Addendum No. 01

Project Name: SLCC Inclusive Restroom Addition

Project No.: 2022560.01

Issued: 12/5/2023

FINISH SCHEDULE -INCLUSIVE RESTROOM

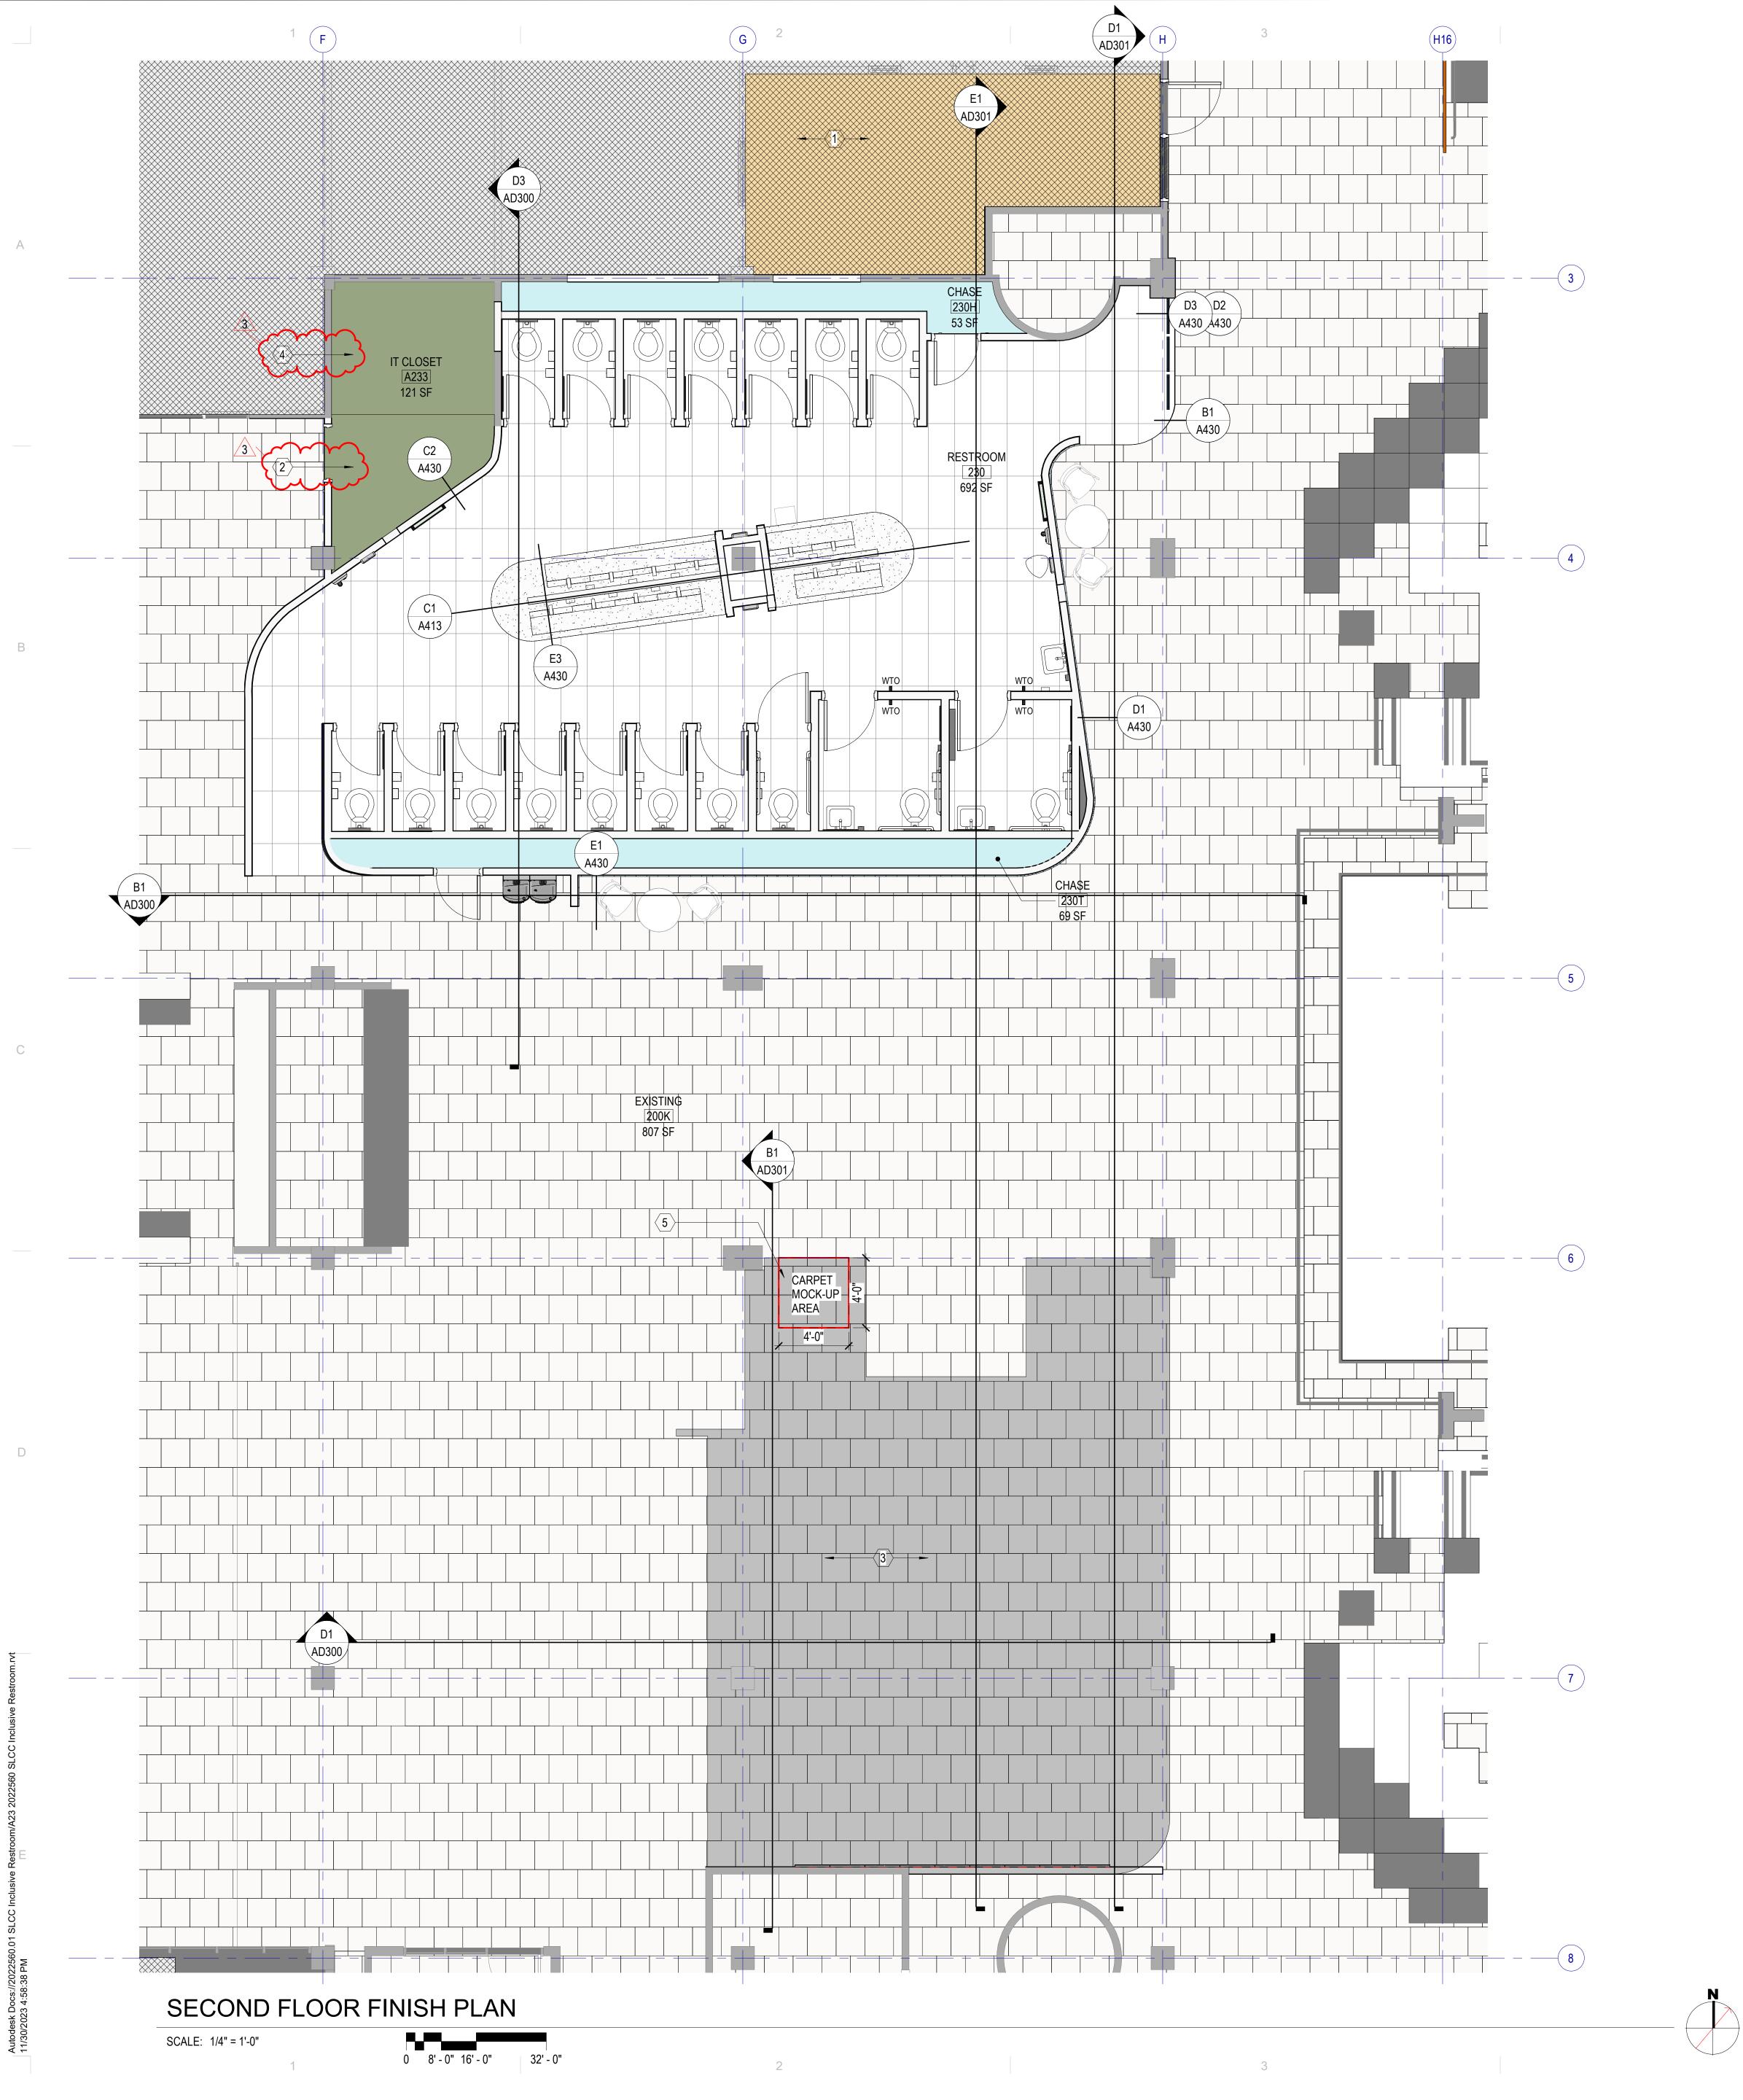
B1.9 Sheet A640 - FINISH SCHEDULE - INCLUSIVE RESTROOM:

Wall finishes revised, PT-6 clarified. Casework finishes revised, bench seating finished not used. Ceiling Finishes revised, GB-1 and GB-2 clarified. Base finishes revised, added RB-1.Finish schedule updated.

- Question: The drywall ceilings outside of the restroom are called out as GB1 on the reflected ceiling plan. This is an epoxy paint as per the finish schedule. Is this correct? It won't match the existing lobby ceiling. THE CEILINGS OUTSIDE OF THE RESTROOM HAVE BEEN REVISED TO GB2, PAINTED GYP. BOARD TO MATCH EXISTING. SEE UPDATED SHEETS A702 AND A640.

- 7. **Question:** Can you please clarify the product type for ceiling finish GB-1 on the finish schedule? It says Armstrong Ultima, which is a ceiling grid product, not paint. THIS CEILING SHOULD BE EPOXY PAINTED GYP. CEILING FINISHES ON A640 HAVE BEEN UPDATED.

A652

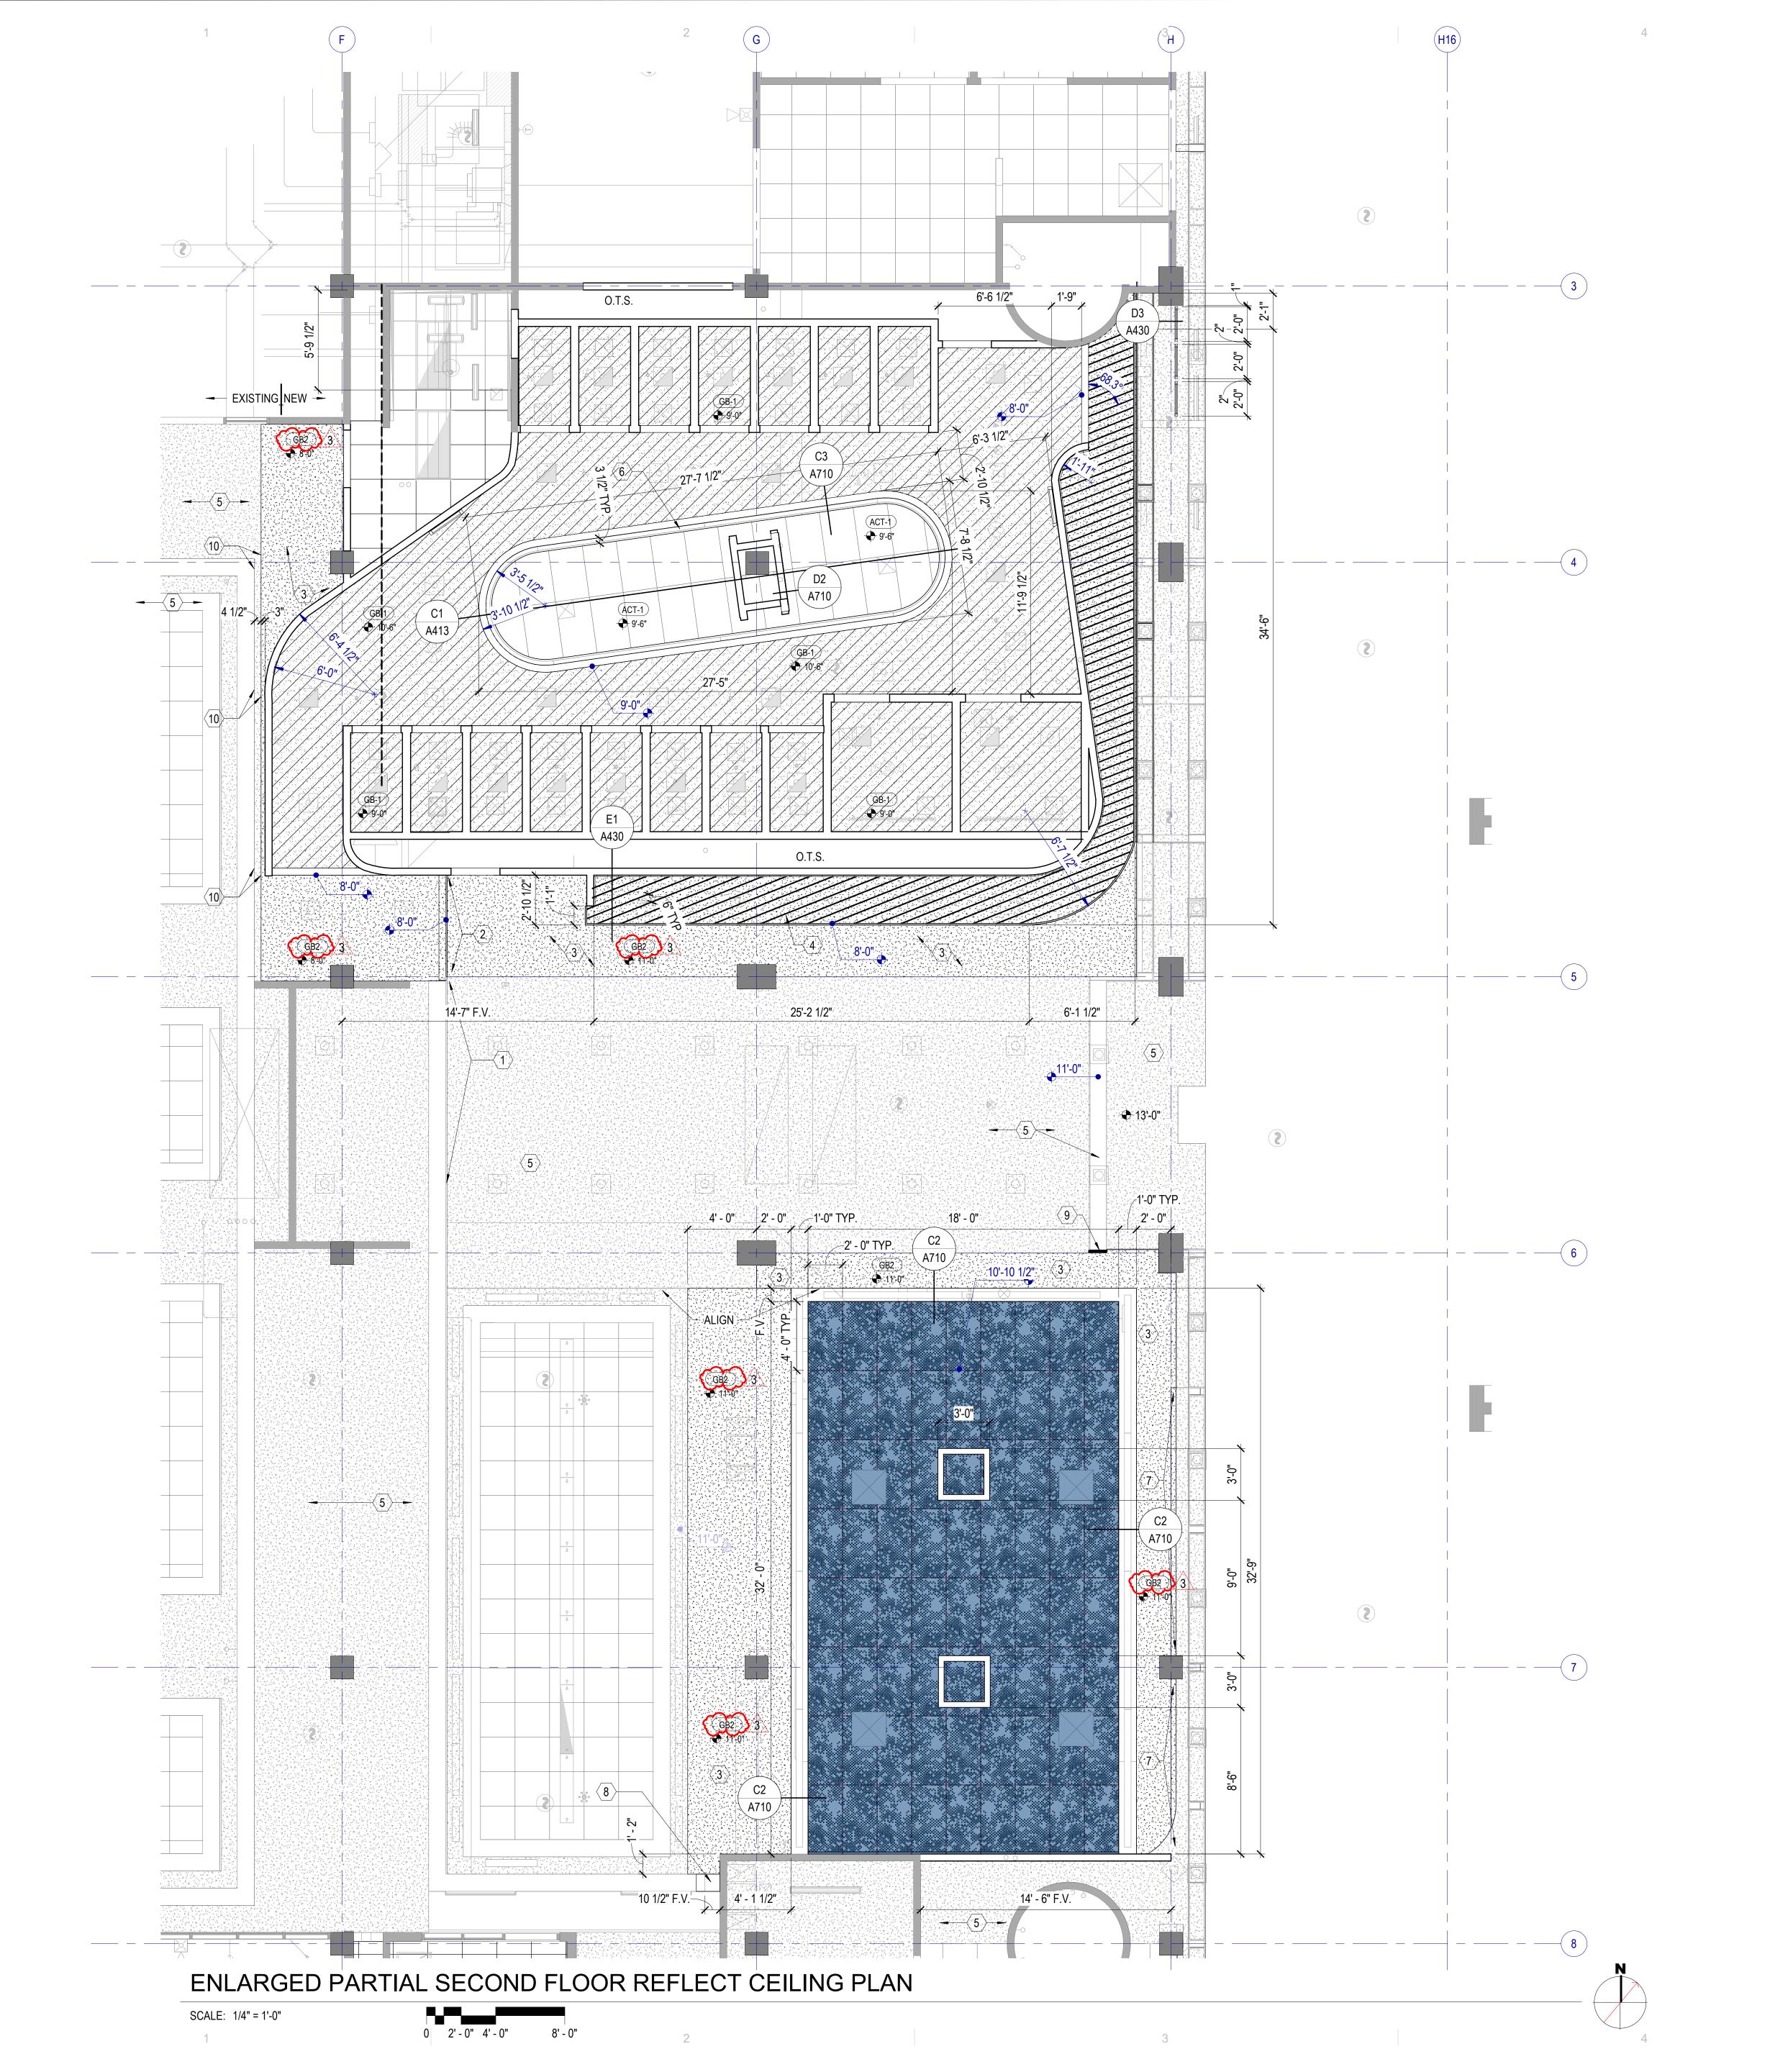
B1.10 Sheet A652 - SECOND FLOOR PATTERN PLAN:

Keynotes for room A233 revised.

- 3. **Question:** There will be floor patching required in room 232 after we demo the wall. Can you please specify the flooring in that room so that we can provide the correct product to match? SHEET A652 KEYNOTES 2 & 4 HAVE BEEN UPDATED. WHERE THE EXISTING WALL IS REMOVED, PATCH AND REPAIR, FINISH WITH SDT-1 AS INDICATED.
